SUBJECT: Transmittal of Revised Responses to AP1000 DSER Open Items

**AP1000 Design Certification Review
Draft Safety Evaluation Report Open Item Responses**

AP1000 DESIGN CERTIFICATION REVIEW

Figure 3.7.2.9-1-1: Node 532 – FRS comparison - Y Direction

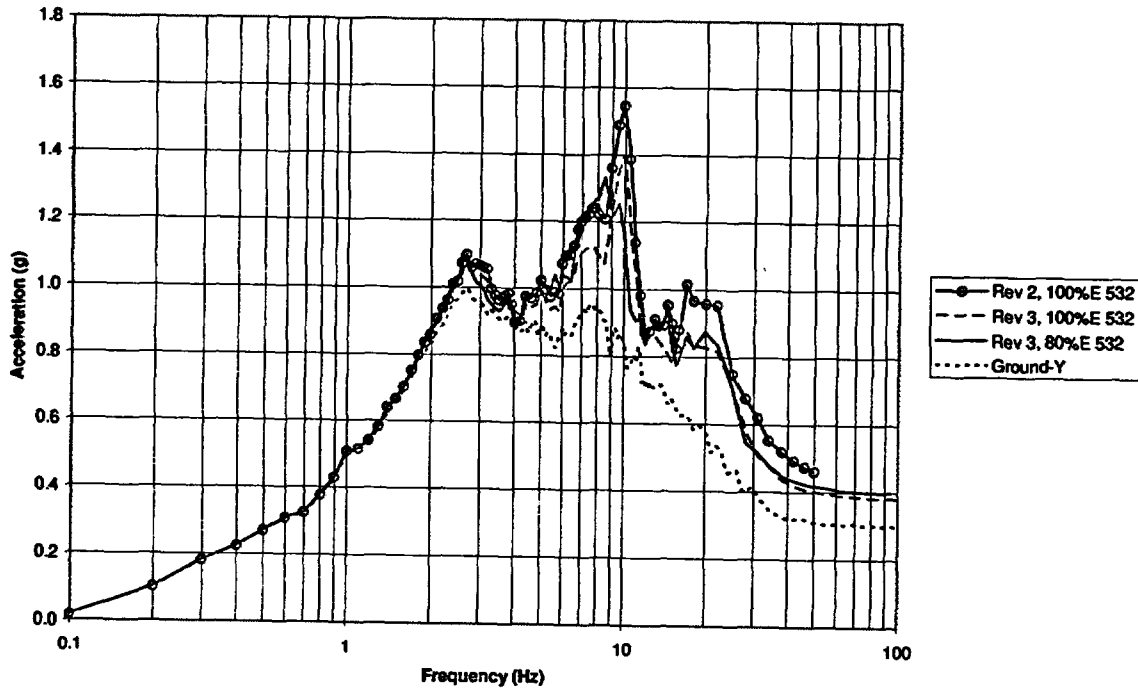
As described in DCD Tier 2 Section 3.7.2.9, as part of accounting for parameter uncertainty, Westinghouse in its response to DSER Open Item 3.7.2.3-1 shows floor response spectra which include the effects of stiffness reduction due to shear wall concrete cracking. In comparing the floor response spectra published in DCD Revision 3 which was based on uncracked concrete properties (100% E), and DCD Revision 6 which is based on partially cracked concrete properties (80% E), it is found that in most instances the 80% E analysis, shows increases in floor response spectra peaks. There are a few instances however where the floor spectra peaks have been reduced. Examples of this are the floor response spectra in the EW (Y) direction of the containment internal structures nodes 532 and 535. The staff would like Westinghouse to cite the reasons that can explain the change in the reduction at these two locations.

Figures 3.7.2.9-1-1 and 3.7.2.9-1-2 show the floor response spectra in the EW (Y) direction of the containment internal structures nodes 532 and 535. The differences between the Rev 2 100% E spectra and the Rev 3 100 %E spectra are due to a more accurate representation of the nuclear island model (including the SCV being attached to the CIS). This more accurate representation included smaller masses at these locations as well as new beam properties based on the CIS finite element model stiffness analyses. The differences between the Rev 3 100% E spectra and the Rev 3 80 %E spectra are due to change from uncracked to partially cracked concrete properties. The reduced stiffness changes cause slight changes in the nuclear island mode shapes that reduce the response in this location.

Figure 5.3-2

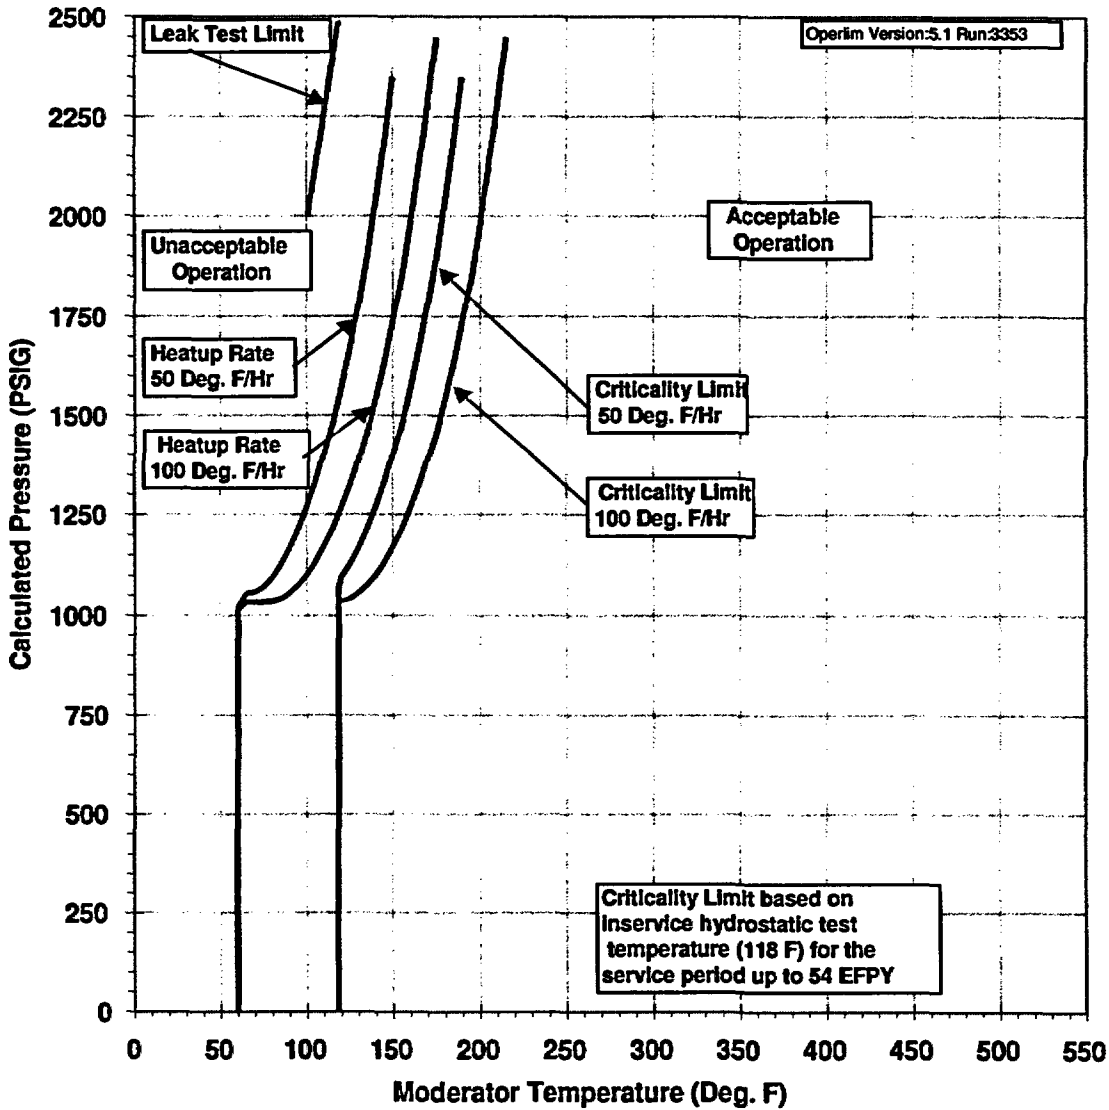
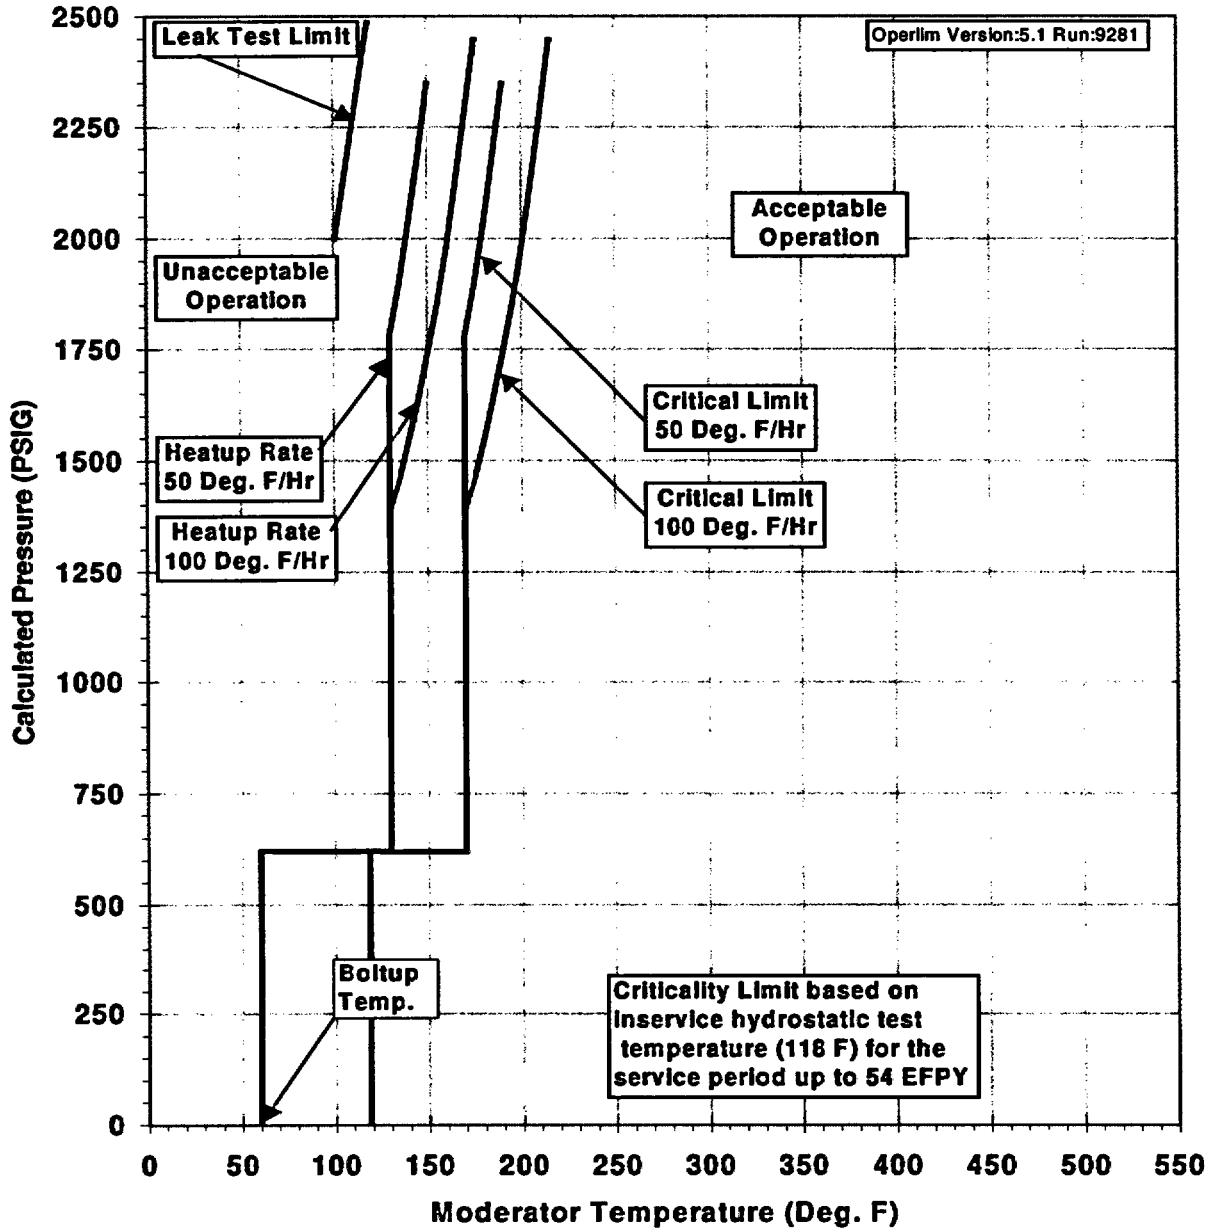
The staff requested, in RAI 251.018, that the applicant demonstrate that the P-T limits are in accordance with Appendix G to 10 CFR Part 50. The applicant responded, that the AP1000 heatup and cooldown operating curves were generated using the most limiting adjusted reference temperature values and the NRC-approved methodology as documented in WCAP-14040-NP-A, "Methodology Used to Develop Cold Overpressure Mitigating System Setpoints and RCS Heatup and Cooldown Limit Curves," with staff approved exceptions.

One exception is that instead of using best estimate fluence values, the applicant is using fluence values that are calculated fluence values. The staff finds this acceptable because this is in compliance with RG 1.190, "Calculational and Dosimetry Methods for Determining Pressure Vessel Neutron Fluence." The other exception is that the K_{1c} critical stress intensities are used in place of the K_{1a} critical stress intensities. This methodology is taken from staff approved ASME Code Case N-641. The staff found the applicant's responses acceptable because the AP1000 P-T limit curves were developed in accordance with 10 CFR Part 50, Appendix G, with the exception that the flange requirement is in accordance with WCAP 15315, "Reactor Vessel Closure Head/Vessel Flange Requirements Evaluation for Operating PWR and BWR Plants." Currently, the staff has not approved WCAP 15315. Any changes to the RV closure head requirements would be incorporated into Appendix G of 10 CFR Part 50. If a relaxation to 10 CFR Part 50, Appendix G is approved, this will allow the operating window to be wider. Since applicants using AP1000 are required to meet the requirements of 10 CFR Part 50, Appendix G, applicants using AP1000 must meet the closure head requirements of Appendix G of 10 CFR Part 50. However, the AP1000 DCD does not provide limitations (values of RTNDT) for the closure flange region of the RV and head. The AP1000 design must include these limitations in order to satisfy Appendix G of 10 CFR Part 50. The applicant should provide these limitations that are consistent with the present TSs and 10 CFR Part 50, Appendix G, or provide closure flange limitations with new TSs that are consistent with 10 CFR Part 50, Appendix G. This is Open Item 5.3.3-1.

Westinghouse will revise the AP1000 DCD to include P/T curves that meet the reactor vessel closure head flange requirements of 10 CFR Part 50 Appendix G. The normal RHR system relief valve setpoint and capacity will also be revised as a result of a revised LTOPS evaluation based on the new P/T curves.
